35/13-99V 21 East Melrose St.
(Chevy Chase Village HD)

HISTORIC PRESERVATION COMMISSION STAFF REPORT

| Case Number: | 35/13-99V | Staff: | Robin Ziek |
| PROPOSAL: | Remove existing driveway, Provide additional off-street parking | RECOMMEND: | Approval |

GALLAGHER & WILLIAMS RESIDENCE
 21 E. MELROSE ST. CHEVY CHASE, M.D.
 1/8" = 10'
 DRIVEWAY REMOVAL & WALL

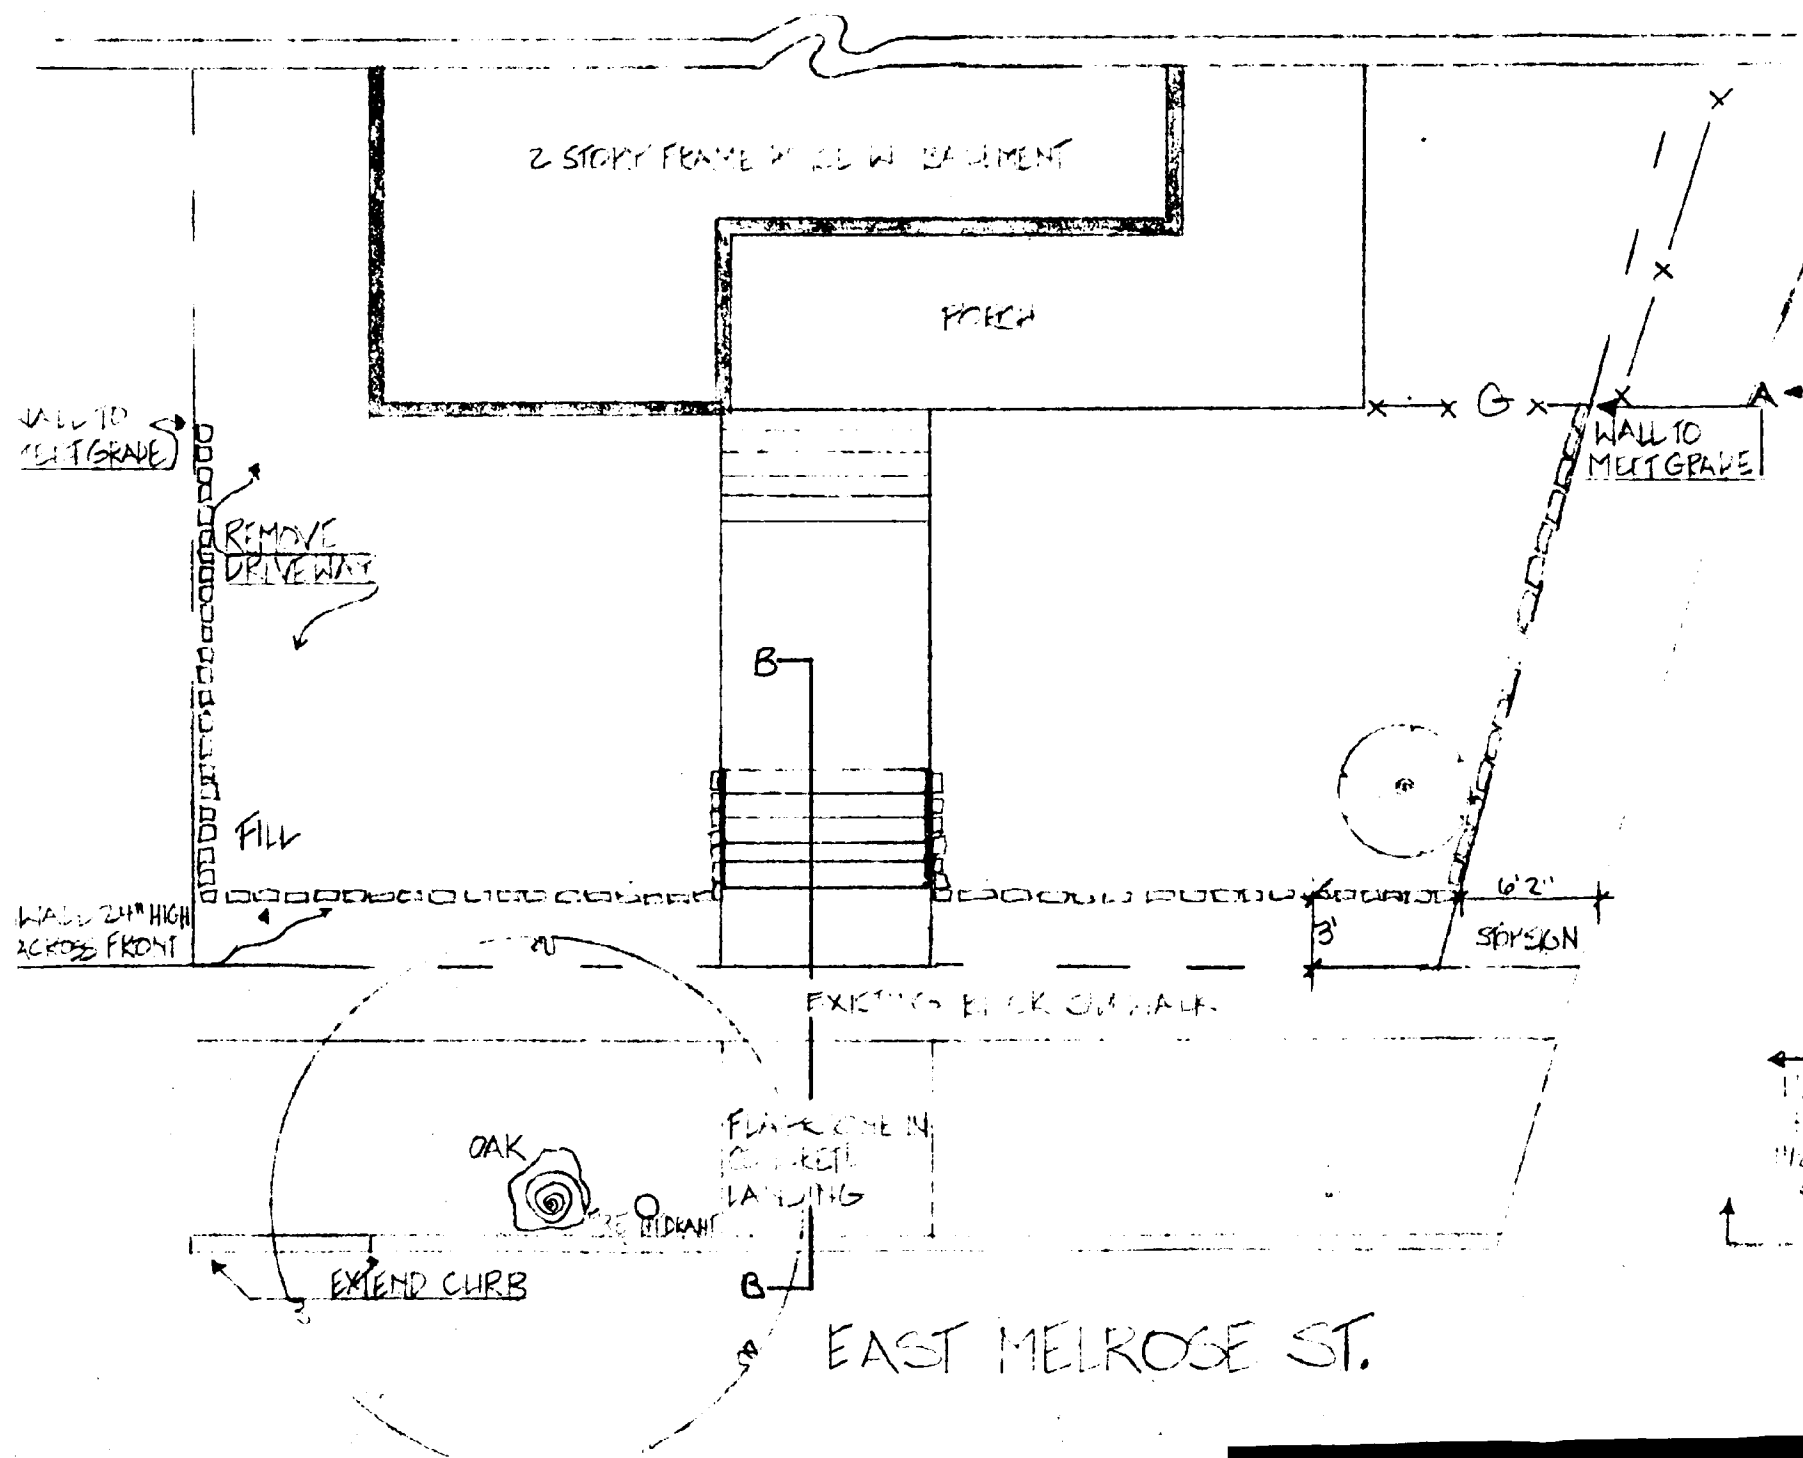
The proposed removal of the driveway on East Melrose Street can be viewed as a restoration of the front lawn area. The additional landscaping, including the low stone retaining wall, is compatible with the district as well as the individual resource. The proposed new landscaping is open, while still holding the sidewalk edge.

EXCAVATION, WALL & CONCRETE PAD

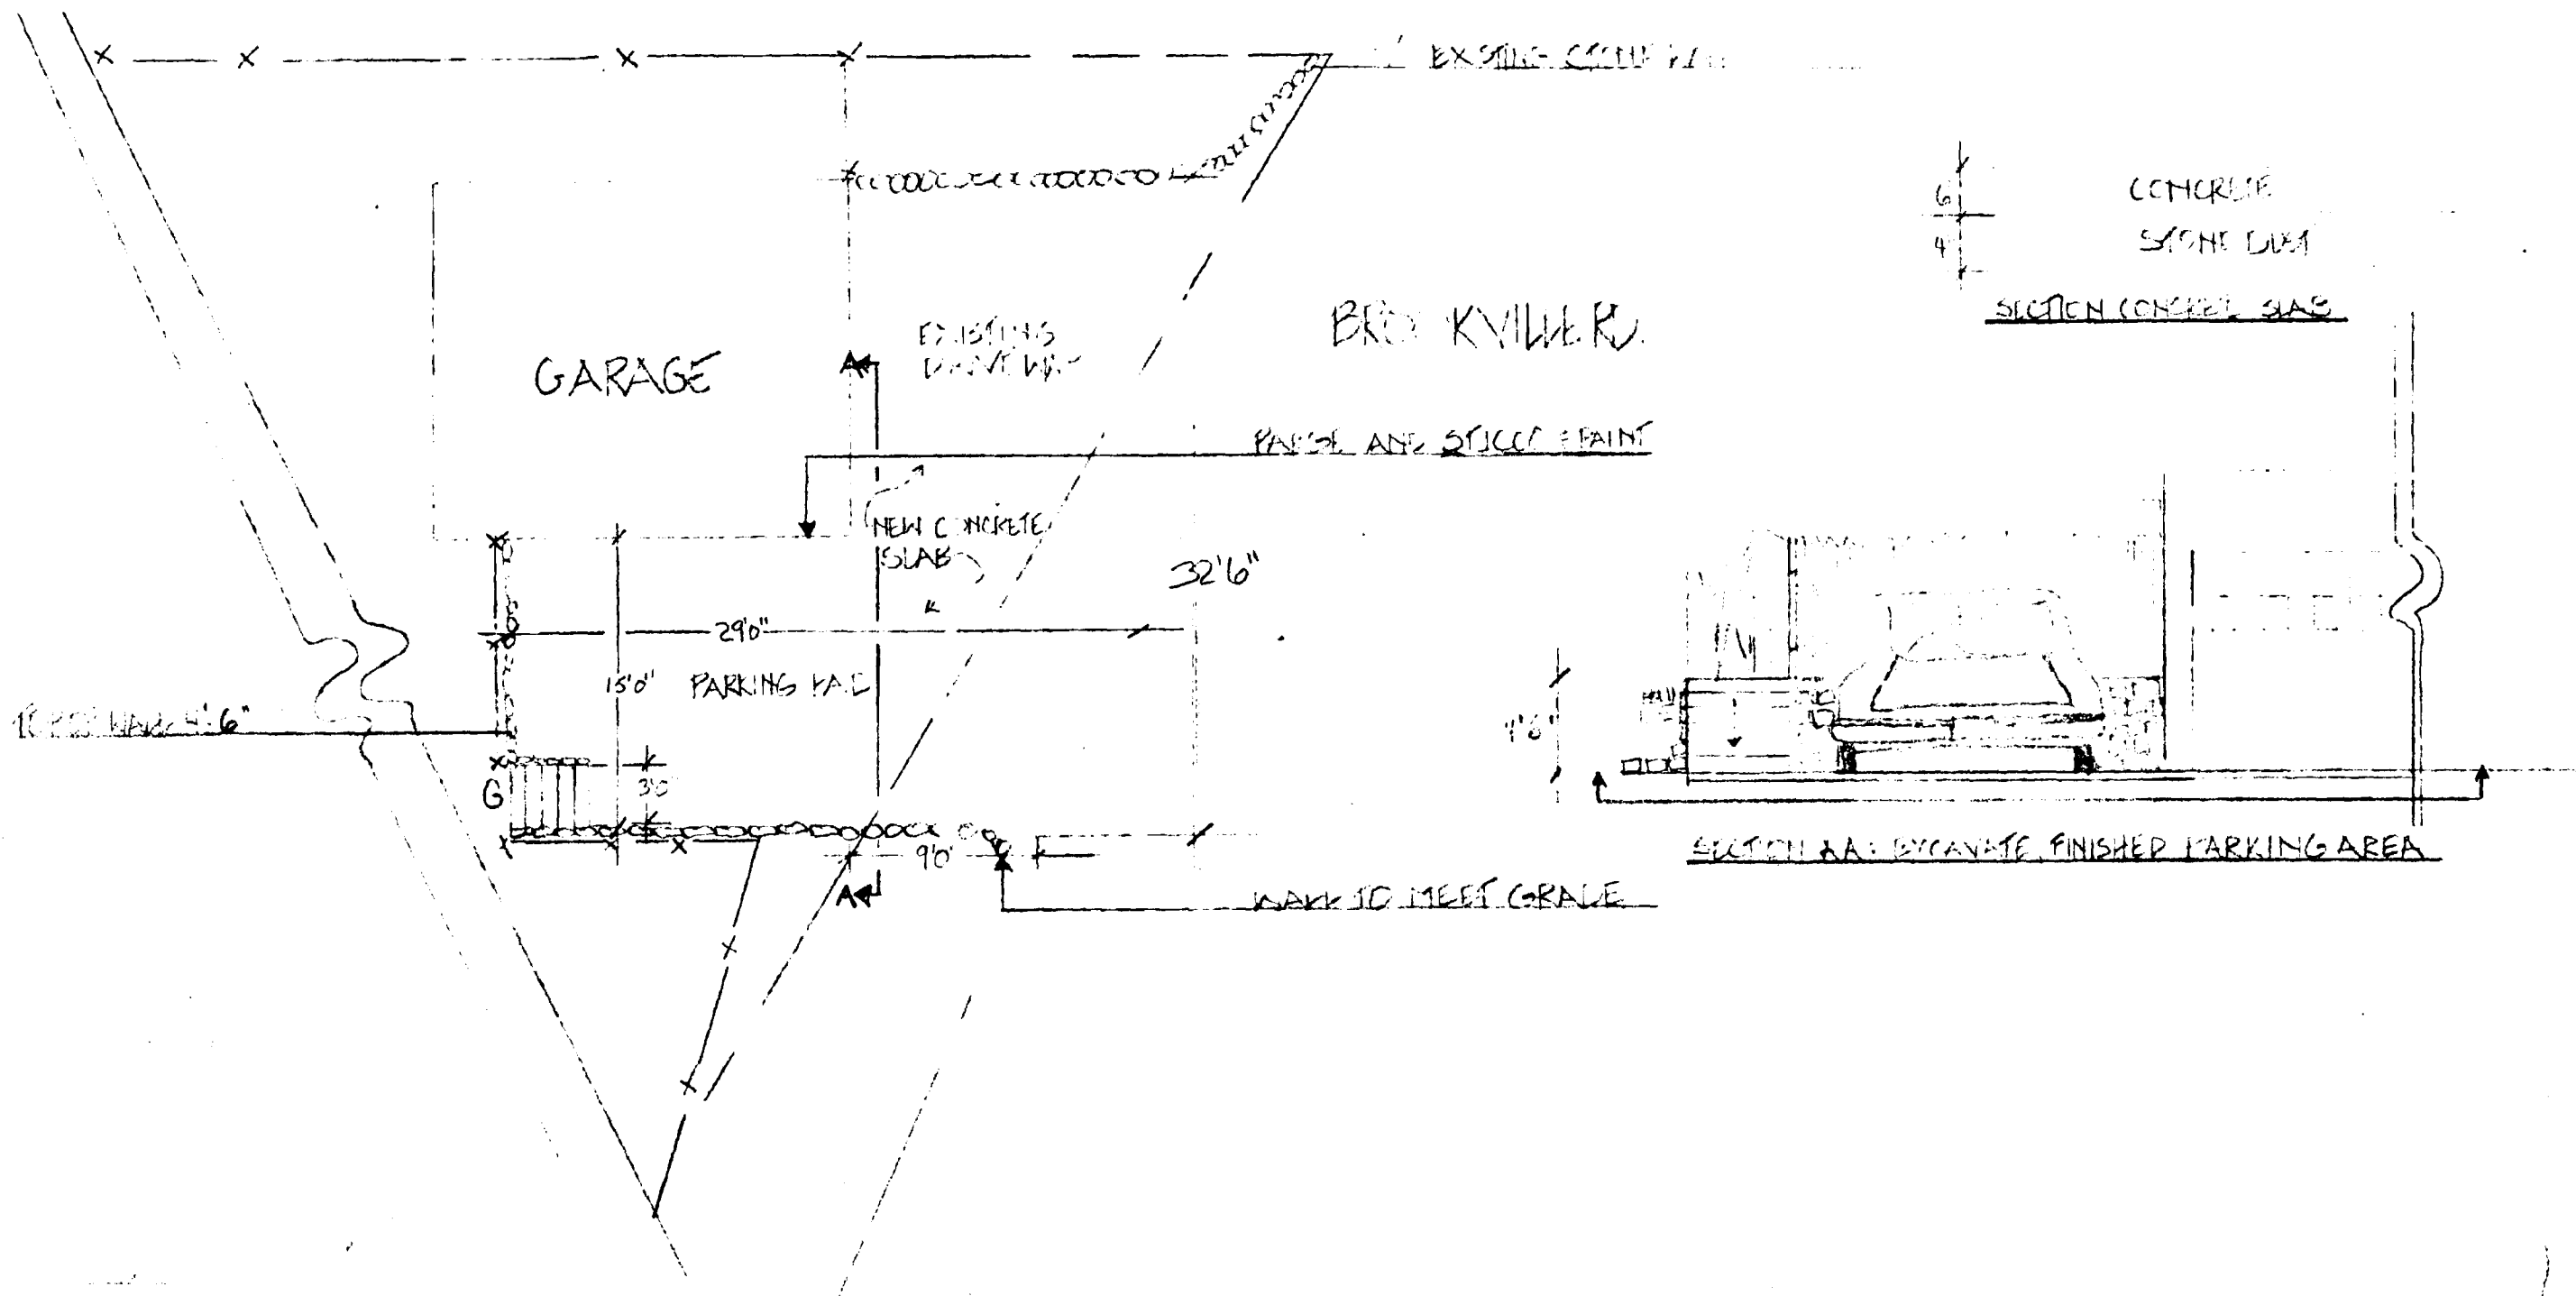
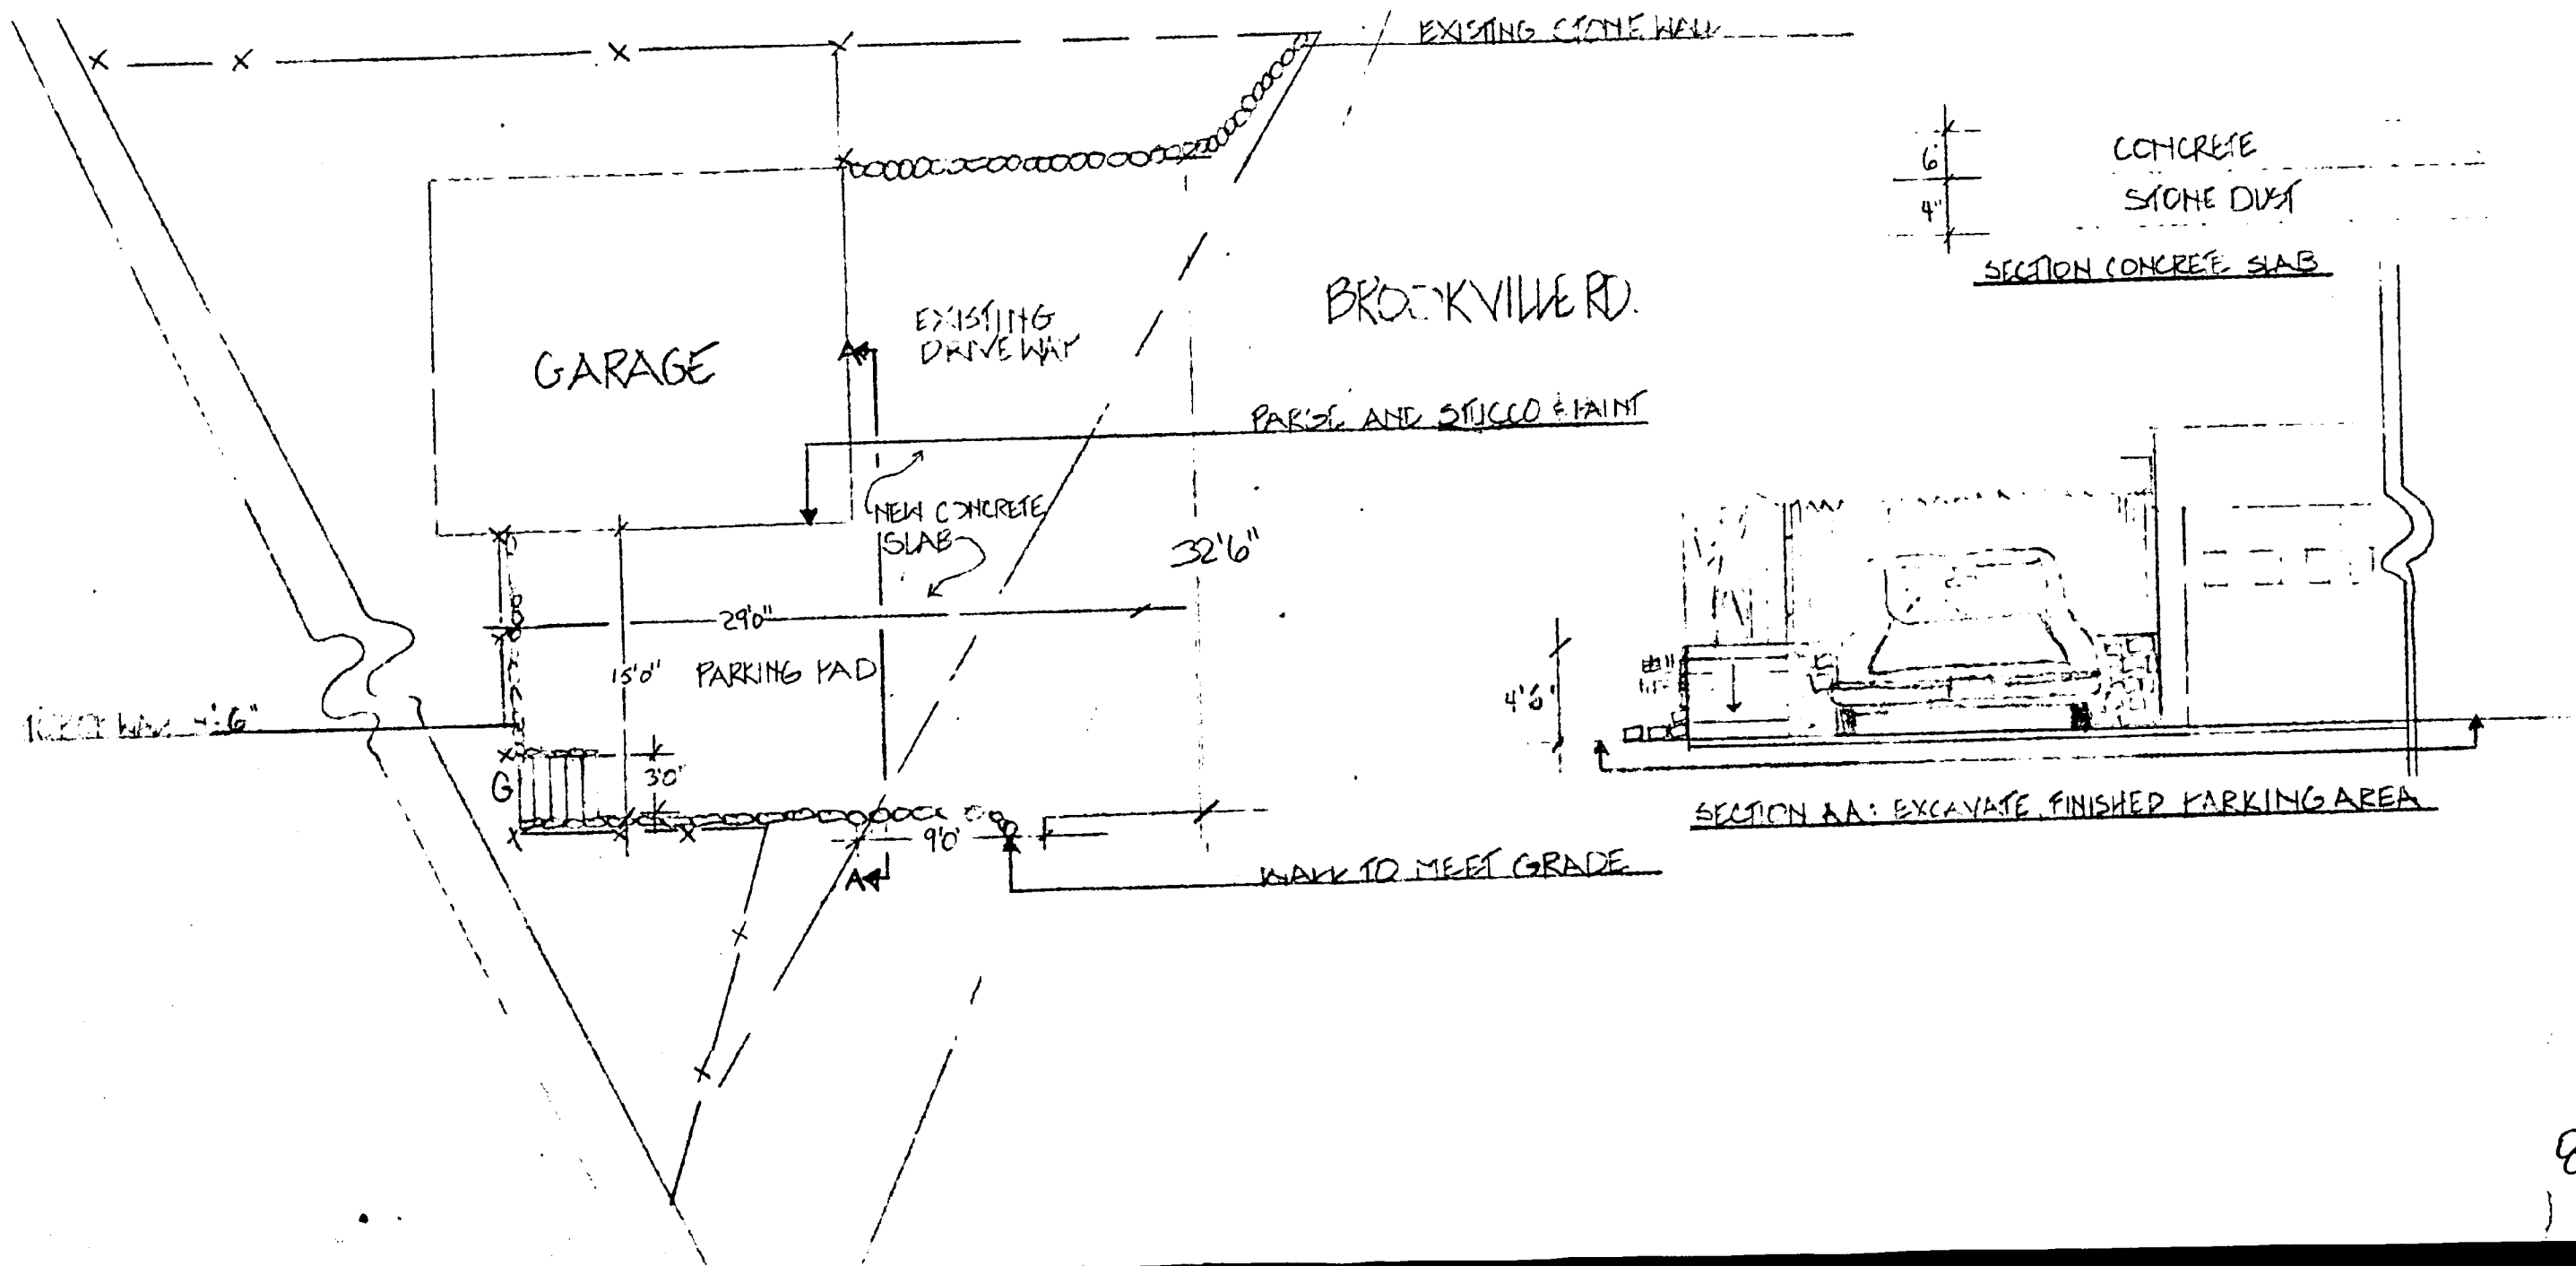
The proposed location of the additional parking area off of Brookville Road appears to be appropriate. Staff has some concerns about the expanse of concrete along Brookville Road at this location. However, the character of the road appears to be evolving more into a service road, as traffic increases and high fences are installed. Staff would suggest that the new stone wall on the south edge of the proposed parking area should be built to match the existing stone wall on the north side of the driveway entrance, to the extent possible.
